TOWN OF OLD SAYBROOK  
**Land Use Department**

**REPORT**

To: Robert J. McIntyre, Chairman, Planning Commission  
From: Christine Nelson, Town Planner  
Christina Costa, Zoning Enforcement Officer  
Sandy Prisloe, Environmental Planner  
Date: November 24, 2010  
Subject: **“The Preserve” Modification to Approved Special Exception for Preliminary Open Space Subdivision (925.82 ac. total) & Open Space (556.83 ac.)**  
Ingham Hill and Bokum Roads (Map 55, 56 & 61/Lots 6, 3, 15, 17, 18)  
Residence Conservation C District, Aquifer Protection Area  
Applicant: River Sound Development, LLC. Agent: Attorney David Royston

## Clark Community Park Trails

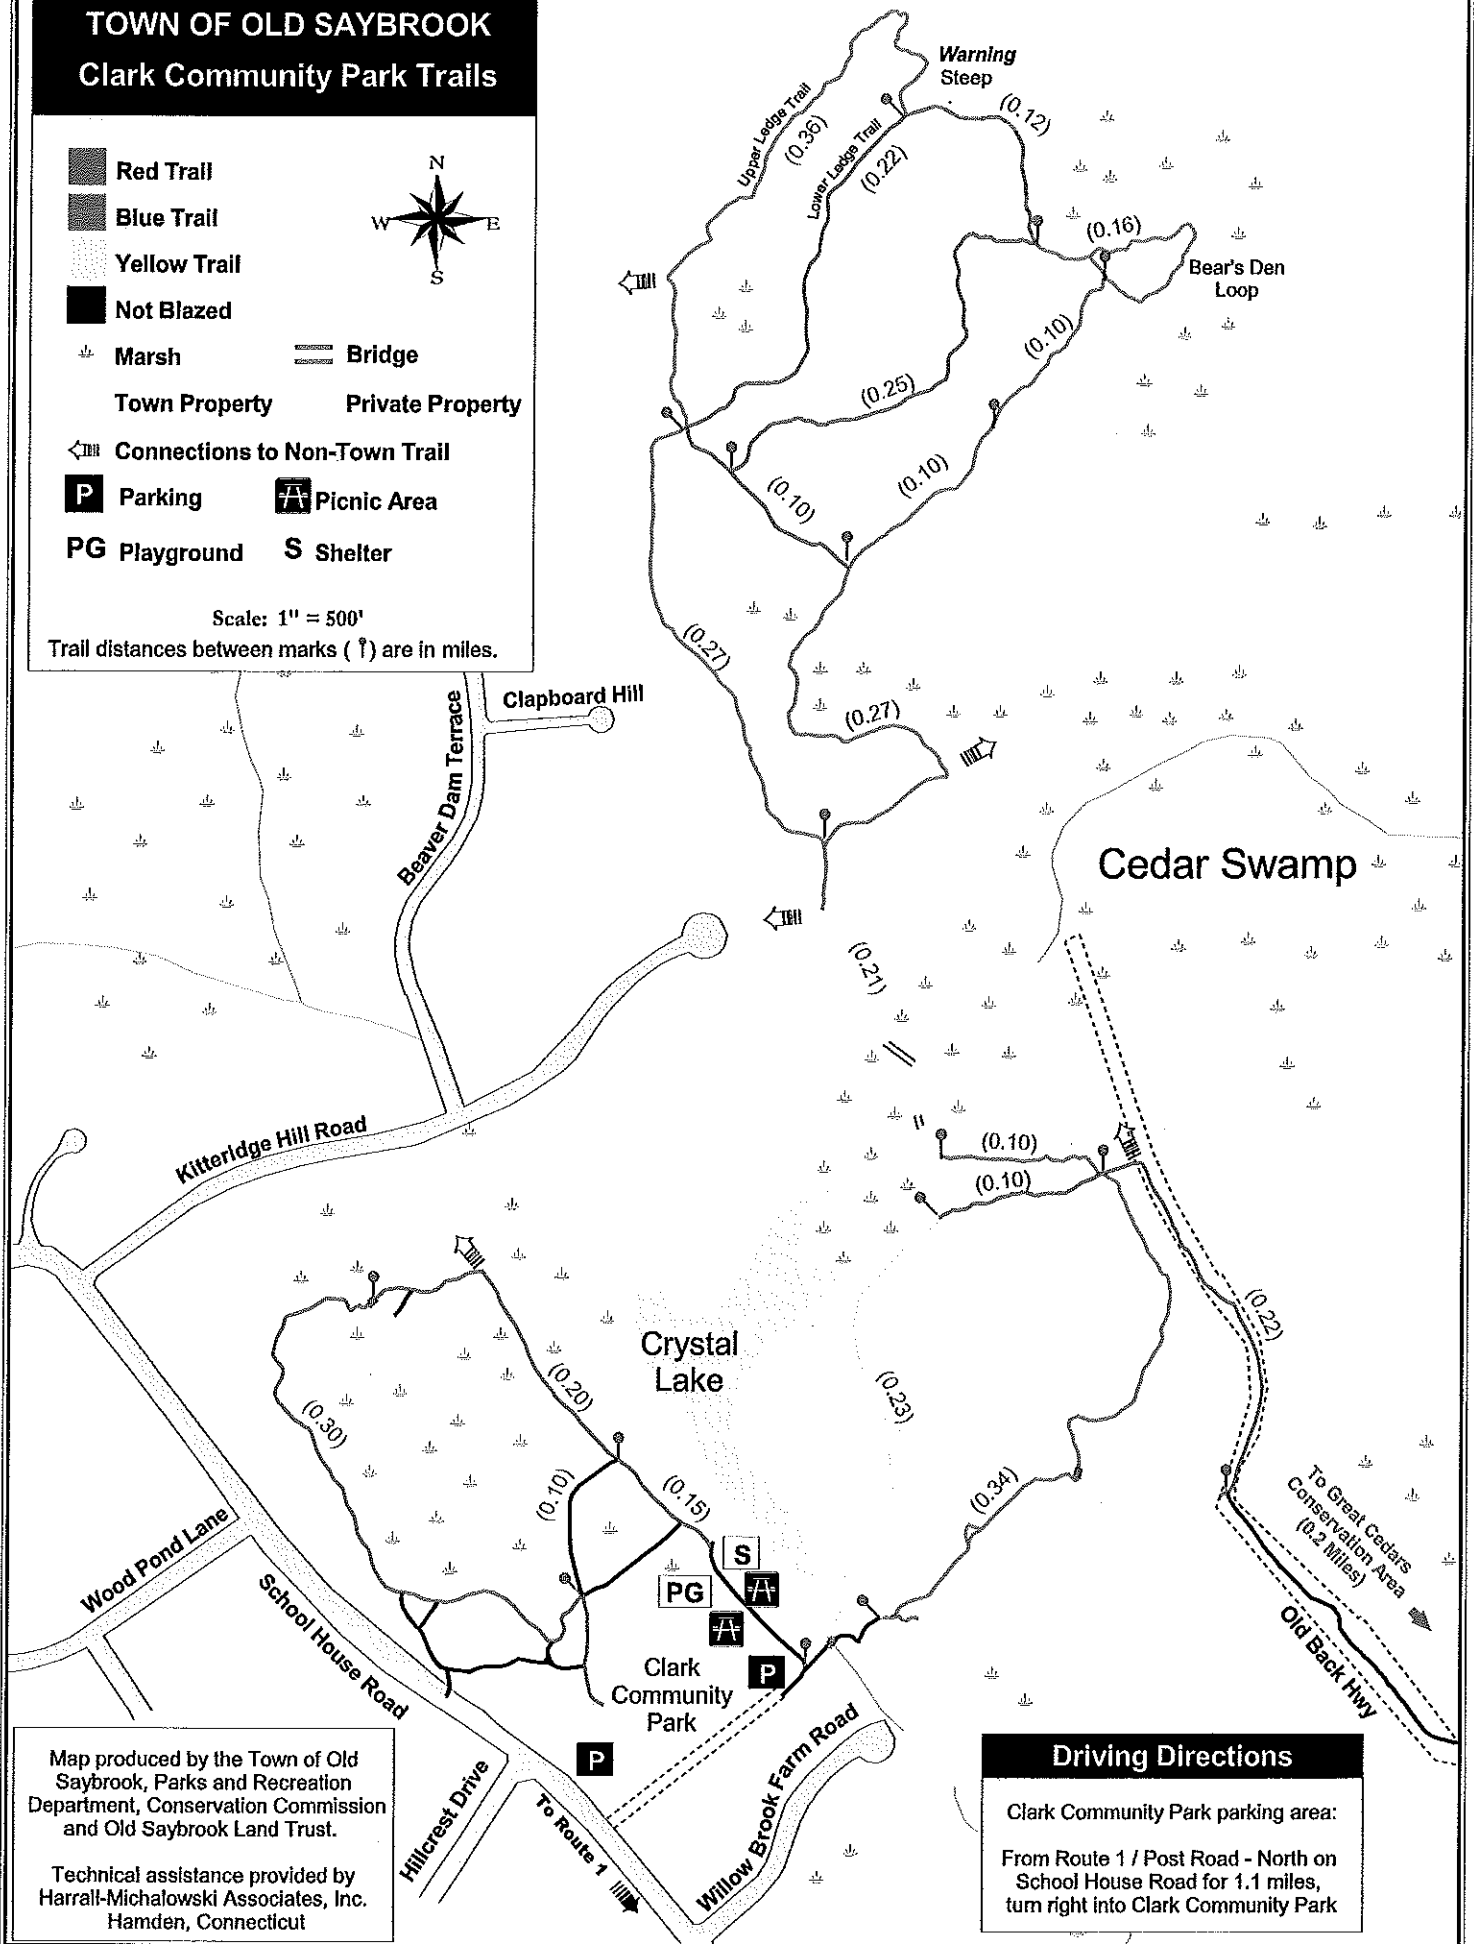
- Replace active recreation within “the core” even if that means a decrease in the yield or a fee in lieu of open space.
- Consolidate lots areas to reconfigure Lot 3 as a dedicated access point to open space area adjacent to Town-owned property; locate the parking area and kiosk as a trailhead to connect to existing trails southerly from Great Cedars Conservation Area/Town Park (trail map attached).
